33511B-03

# Modification Recommended Service Note

## 33500 Series Waveform Generator

Serial Numbers: MY50000000-MY57301823 / SG50000000-SG57300602

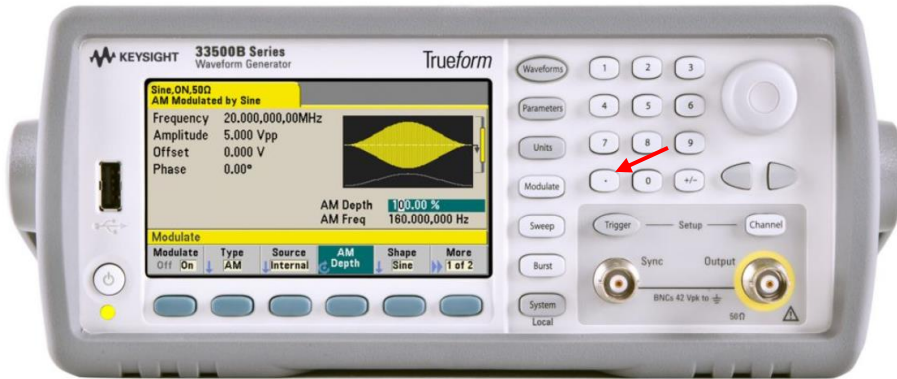
The Problem – The dot key  on front panel intermittently not active.

User may experience the dot key on the front panel intermittently inactive when pressed.

P/N	Description	Qty.
33500-66308	Tested Front Panel PCA	1pc

1. Replace the front panel board (part number: 33500-66308).
2. Turn on the instrument and check if the dot key is active when pressed.
